BID Addendum-01

Project No.
JCDT23-0185

Title
Bid Clarification 01

Project Name
St Clair County Heath Dept Relocation

1 LOW EAVE w/ GUTTER
A71-01 SCALE: 3" = 1'-0"

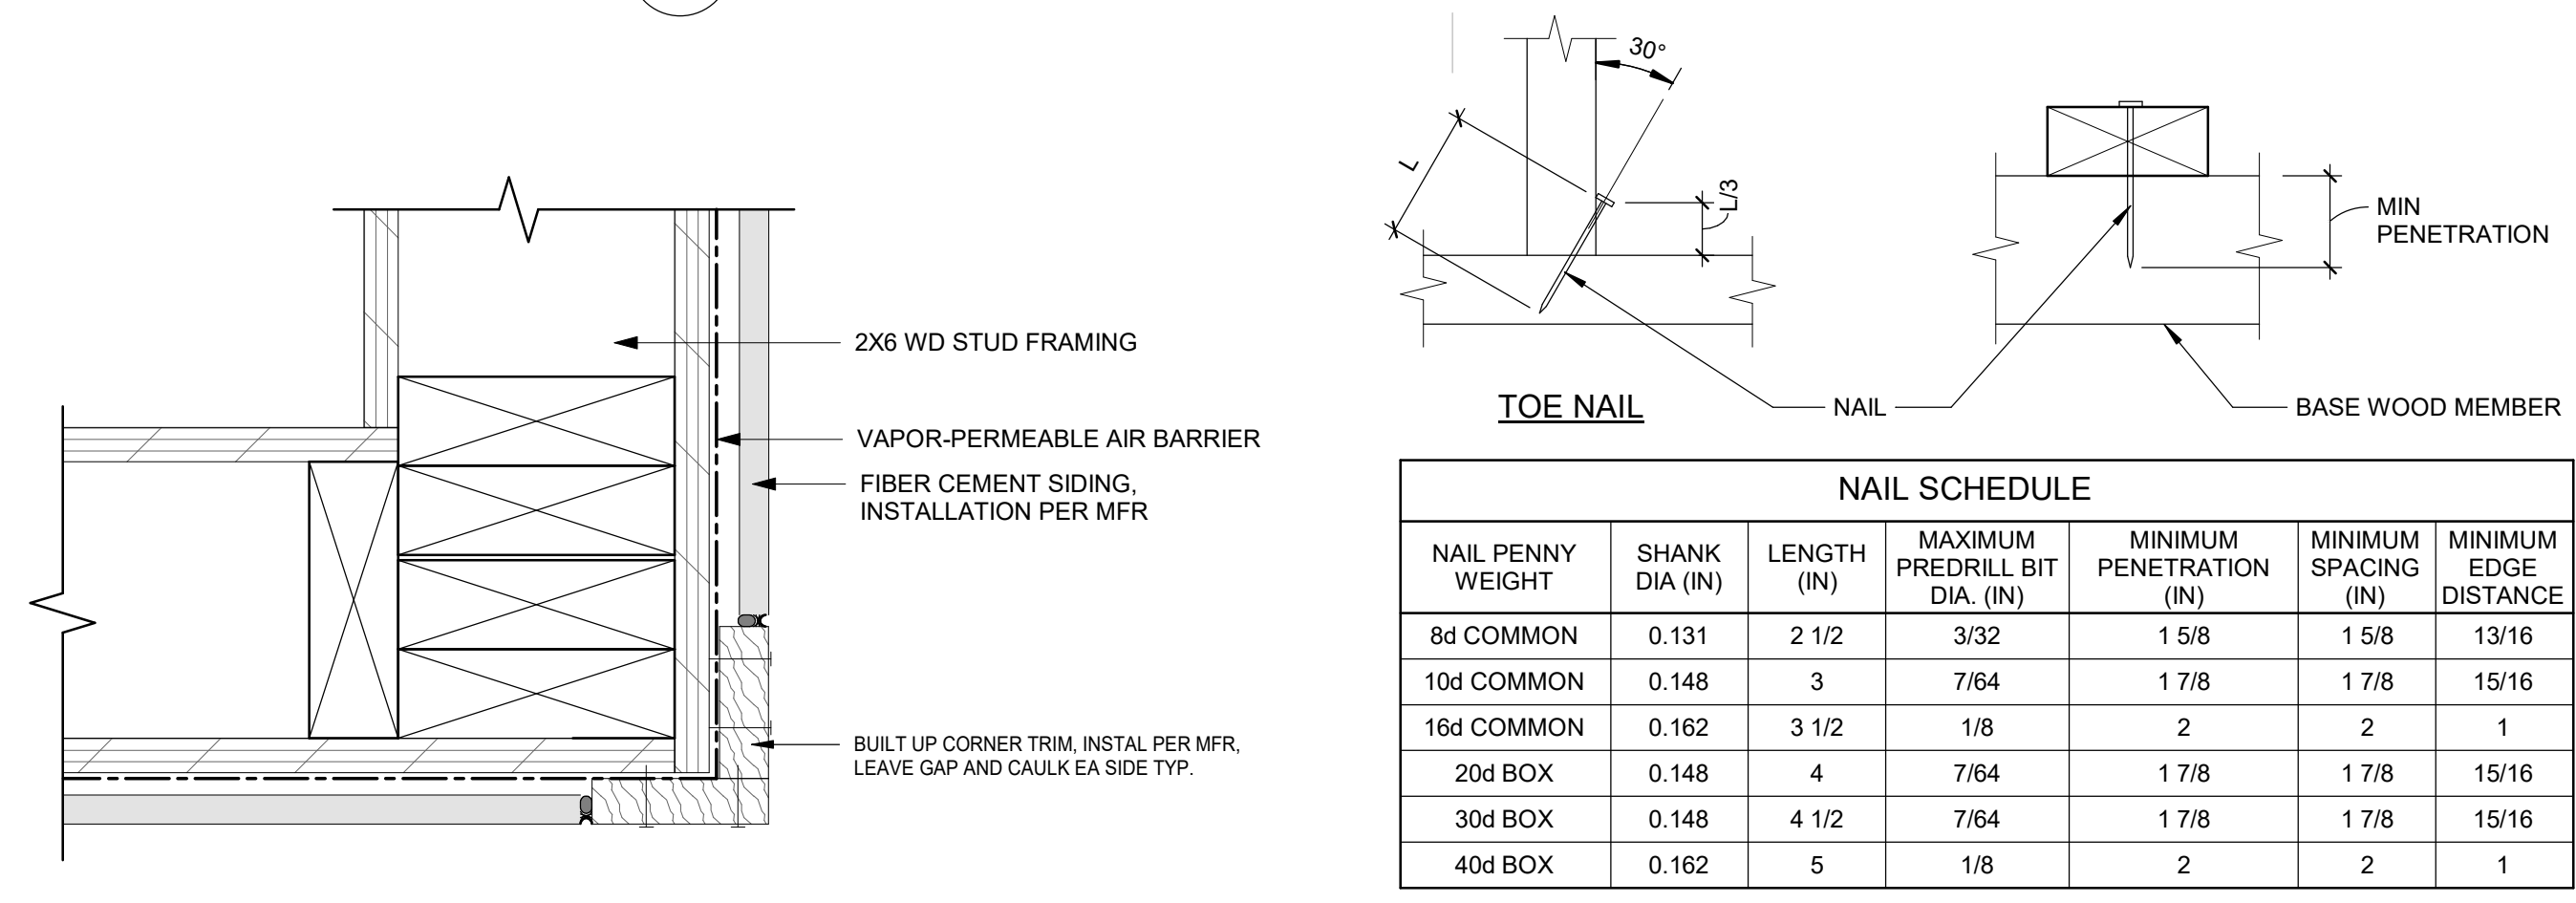
5. Sheet A71-01 -SCHEDULES AND PLAN DETAILS
 - a. Revised detail 1 to include Fully Adhered 0.60 EPDM roofing system and 2:12 roof pitch as indicated.
